38TH FLOOR FRAMING PLAN

BANKERS TRUST PLAZA

THE OFFICE OF JAMES RUDERMAN STRUCTURAL ENGINEERS
515 MADISON AVENUE N.Y. N.Y. 10022

DRAWING NUMBER S-26

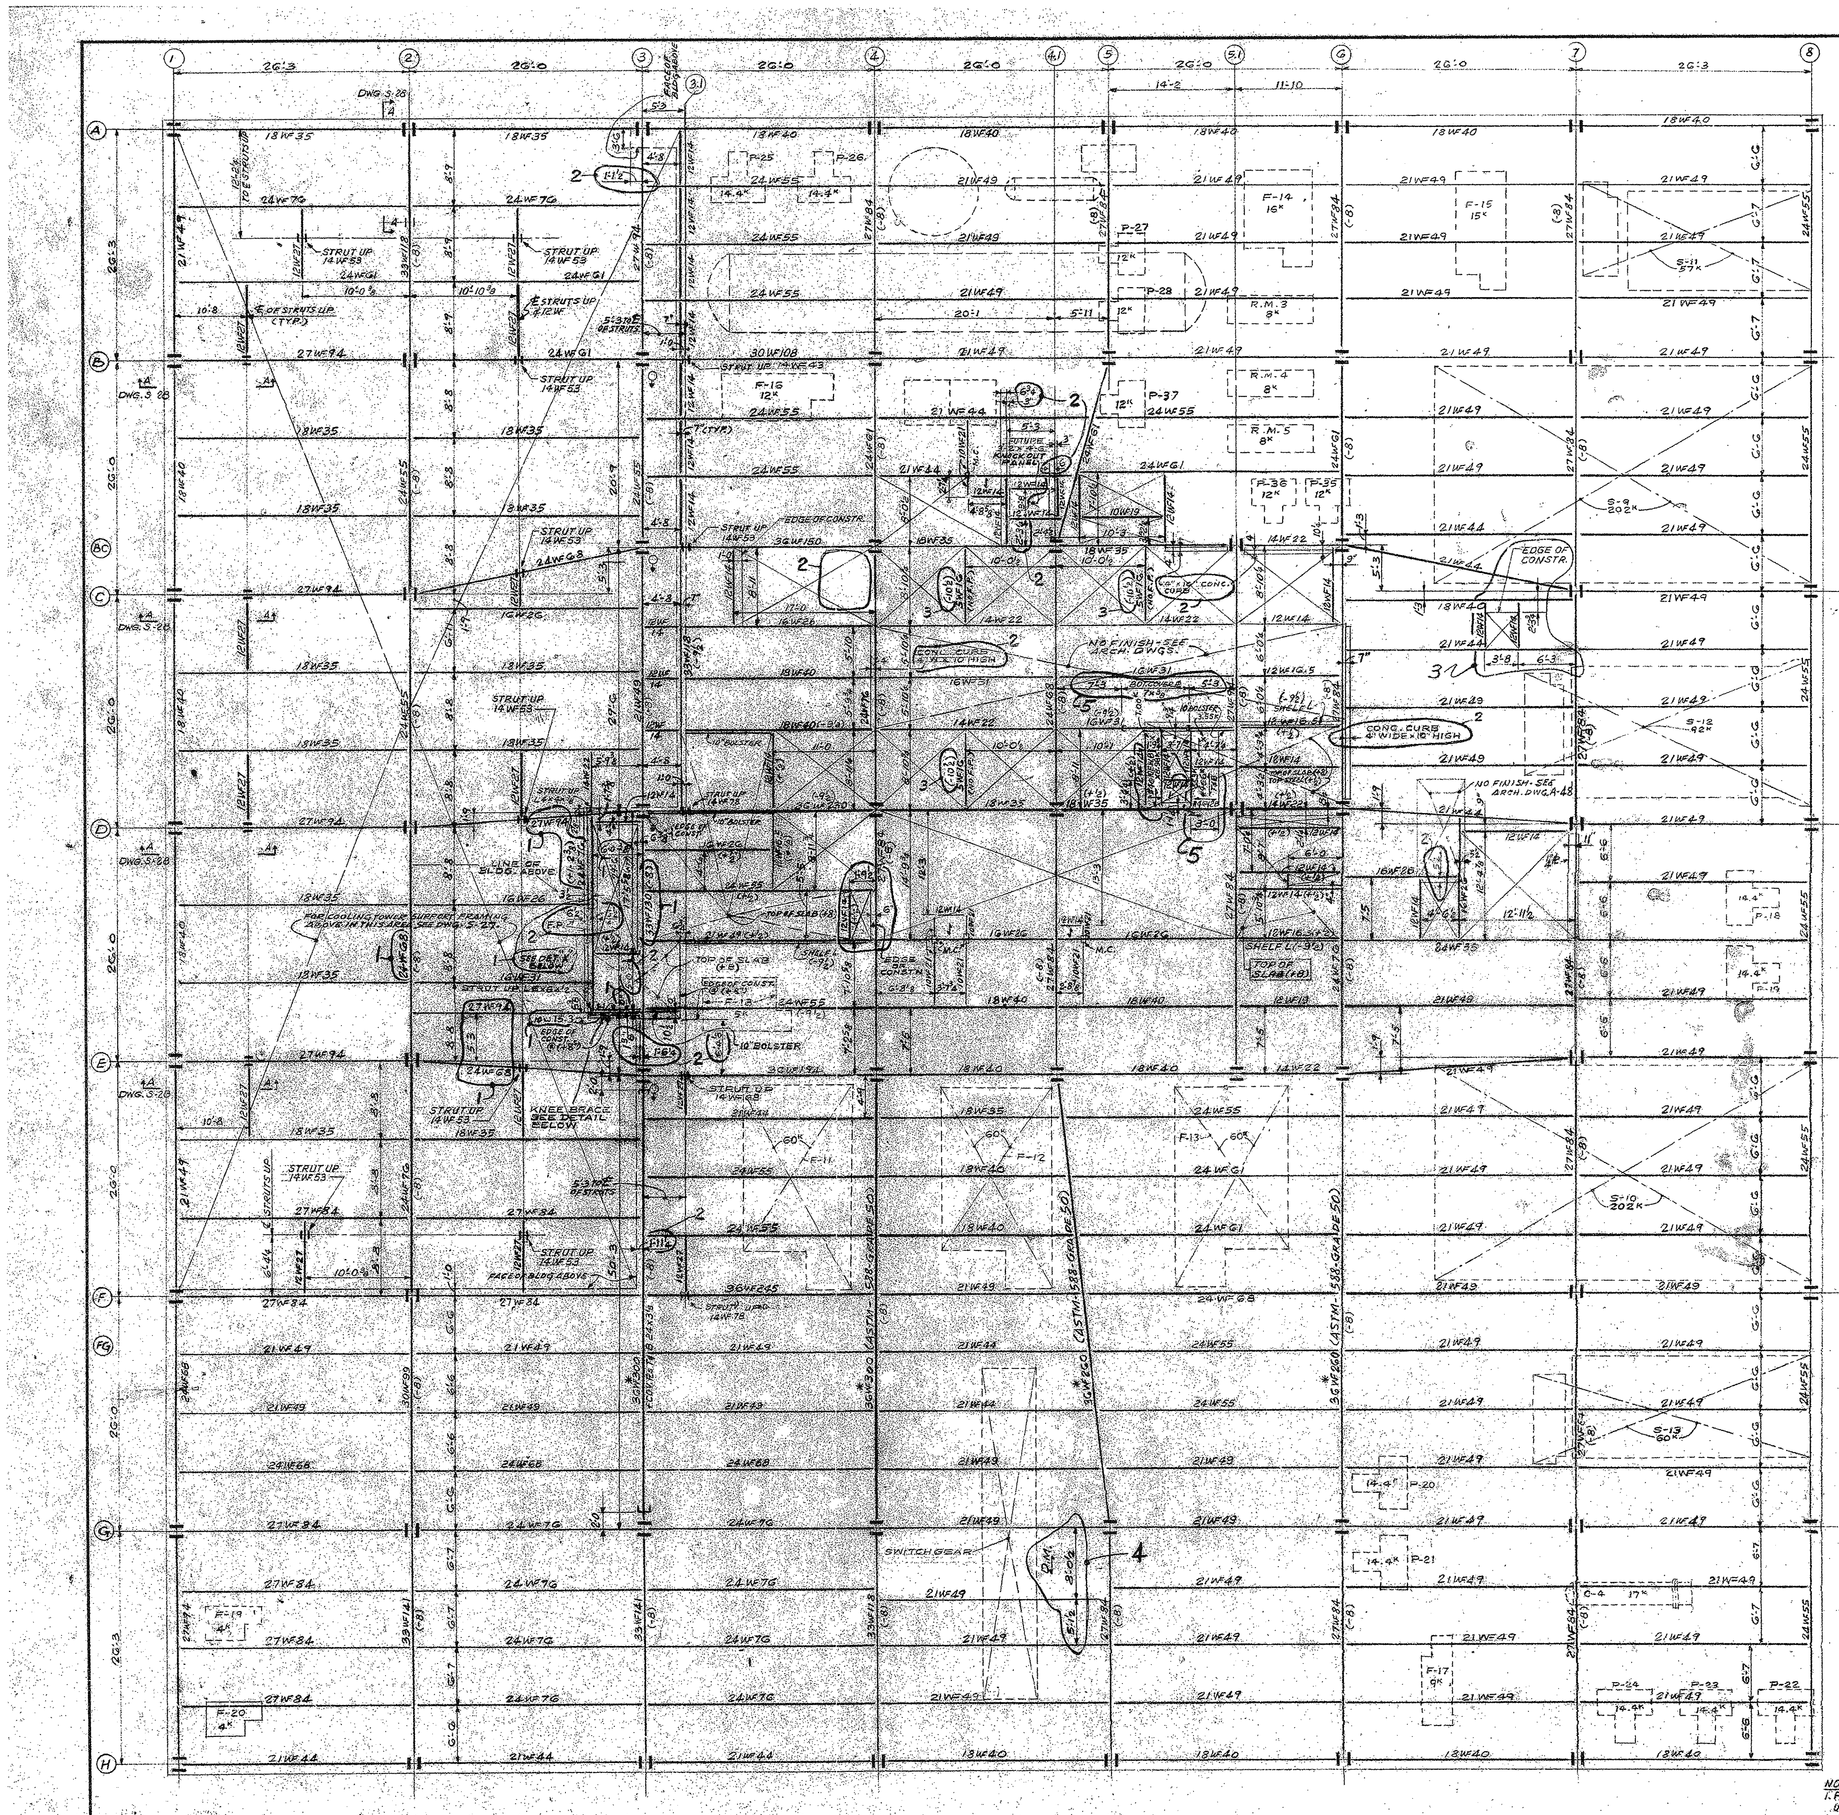
REVISIONS		
NO.	DATE	DESCRIPTION
1	6-12-72	REVISED AS CIRCLED <>1
2	7-10-72	ADDED BEAM AT KNOCK-OUT PANEL NEAR COL. BC-6.1; AND REMOVED 3 BEAMS NEAR COL. BC-4, AS CIRCLED <>2 ADDED BEAM & OPENING NEAR COL. A2
3	8-4-72	REVISED ELEVATION OF SWI6 BEAMS BETWEEN ELEVATOR SHAFTS, ADDED OPNS. NEAR COL. C-7, REVISED AS CIRCLED <>3
4	8-29-72	MOVED BM. NEAR COL. G4-G5 FOR CONSTRUCTION HOIST AS CIRCLED <>4
5	10-13-72	DIM. ADDED @ COOLING TOWER SUPPORT
6	12-1-72	ADDED REINF. NEAR COL. D-5.1 FOR CONVEYOR DRIVE LOADS, ADDED BOTTOM COVER PL, REVIS. <>5
